Final Environmental Statement

related to Primary Cooling System
Chemical Decontamination at
Dresden Nuclear Power Station, Unit No. 1
Docket No. 50-10

Commonwealth Edison Company

**U.S. Nuclear Regulatory
Commission**

Figure 2.1 Average Exposures in Man-Rems Per Year.

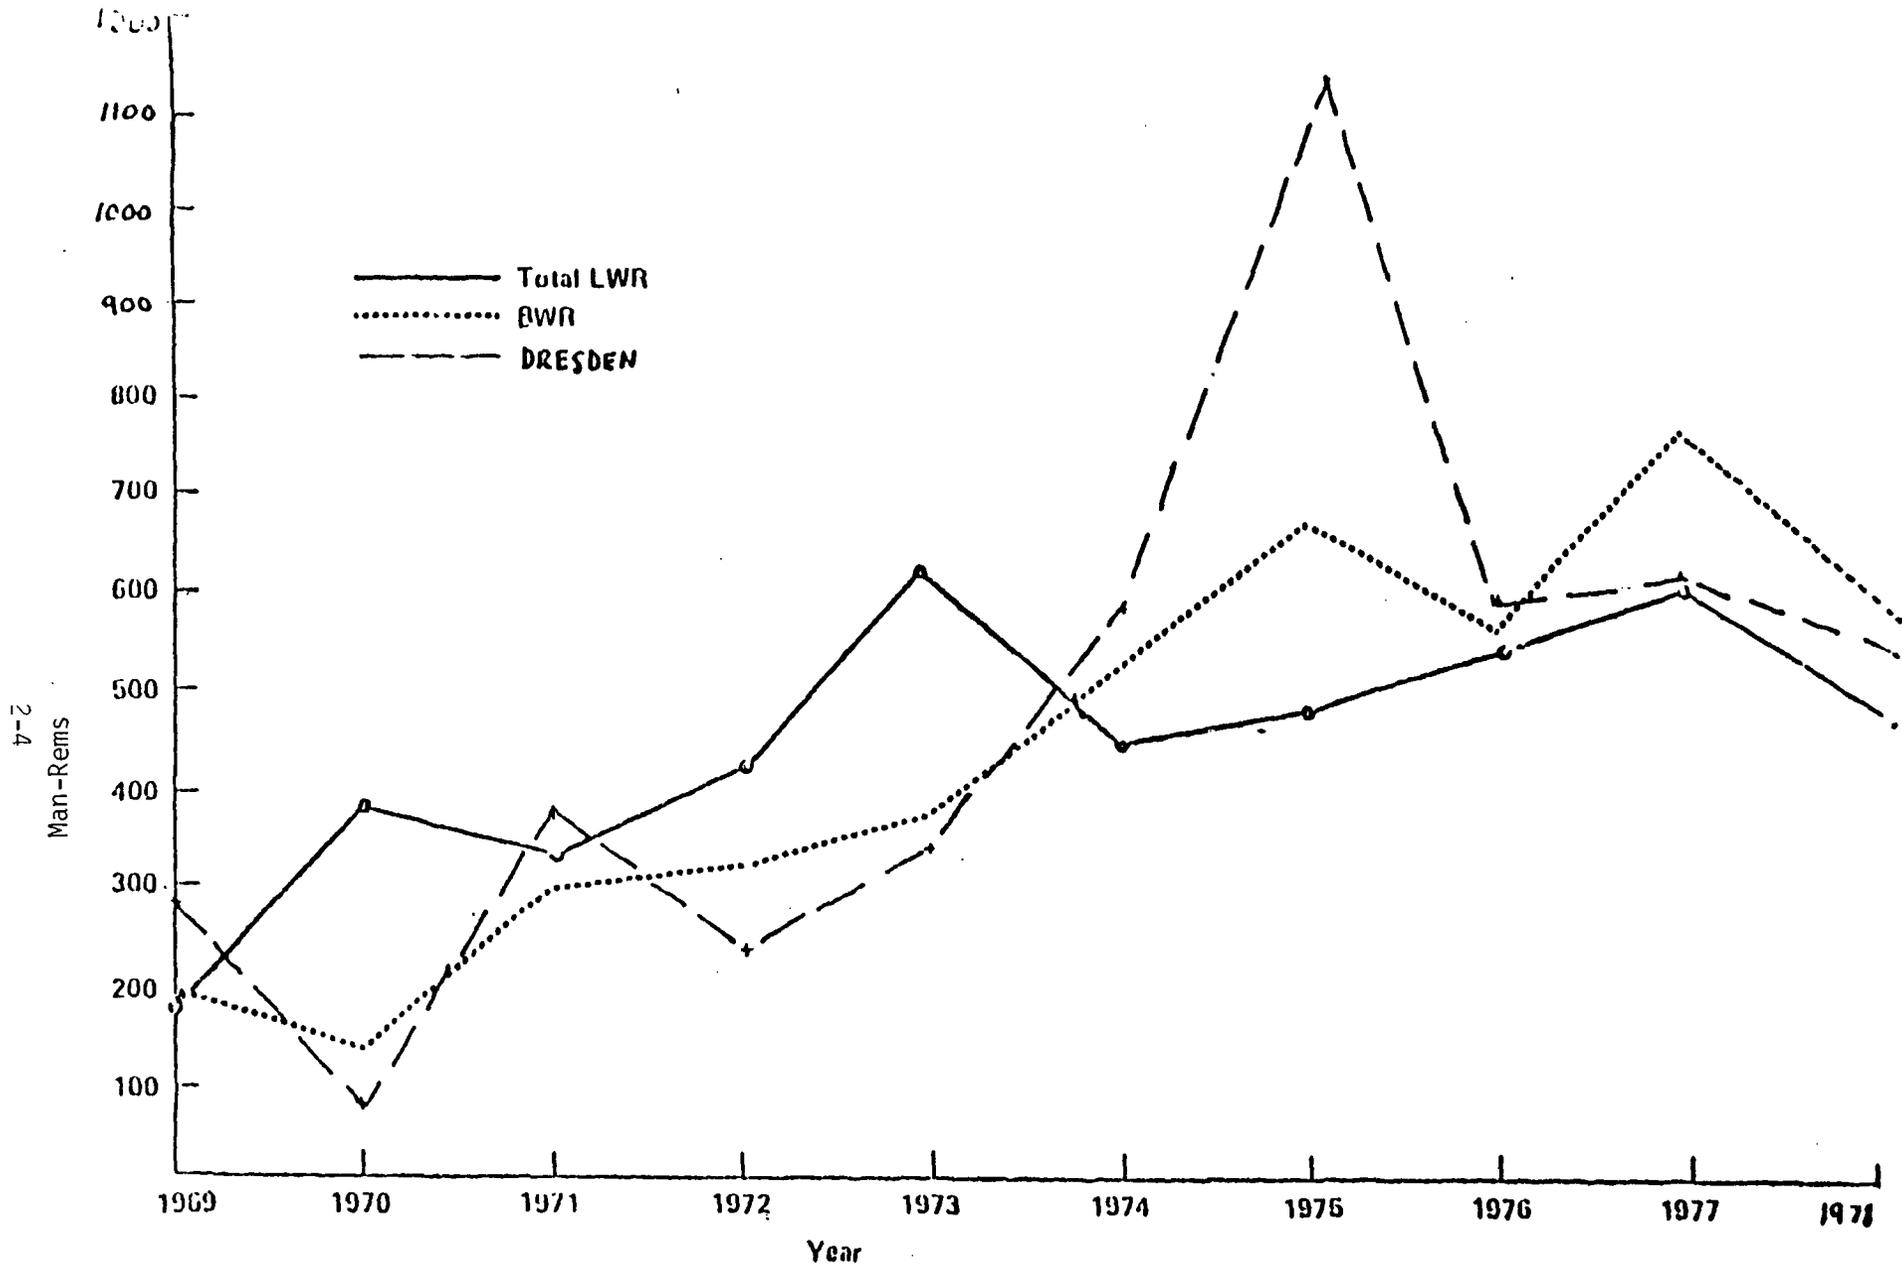
Unfortunately, the pages of the draft document are not consistently numbered, so comment is made more difficult than normal. However, I will try to make clear comments despite this drawback in the document. Figure 1, following page 2-2, should be re-drawn with the units converted from reactor-years to gigawatt-years of reactor operation. This would give a more meaningful standard of comparison than is the case with the current figure. More importantly, the figure as given shows one of two things: (a) either the Dresden reactor is not in need of decontamination because (with the exception of anomalous man-rem doses in 1975) it is operating at or below the average of all BWR dose-rates, or (b) all BWRs are in need of decontamination because they are giving higher dose-rates than the Dresden plant.

If the Dresden plant is giving doses lower than the average of BWRs, then why does Dresden need decontamination? If Dresden needs decontamination and it is giving below-average doses (compared to the average of all BWRs), then Dresden is really just the first experiment in a BWR decontamination program and the impact statement should be a programmatic impact statement or a generic impact statement covering the entire program of BWR decontamination. From Figure 1, one could also conclude that Dresden exposure experience is so close to the average of all LWR exposure experience that the remarks made above could apply equally well to all LWRs. Either Dresden doesn't need decontamination because (with the exception of the anomalous year, 1975) it is very close to the average of all LWR exposures, or, alternatively, all LWRs need decontamination. If the latter case is true, the Dresden decontamination is just the first step in a decontamination program and the entire program should be the subject of this DEIS. Table 2, on the page following Figure 1, again demonstrates that Dresden is not giving exceptionally high exposures or exposure-rates, relative to other BWRs, and thus either (a) Dresden doesn't need decontamination or (b) all BWRs need decontamination and this EIS should cover the full decontamination program.
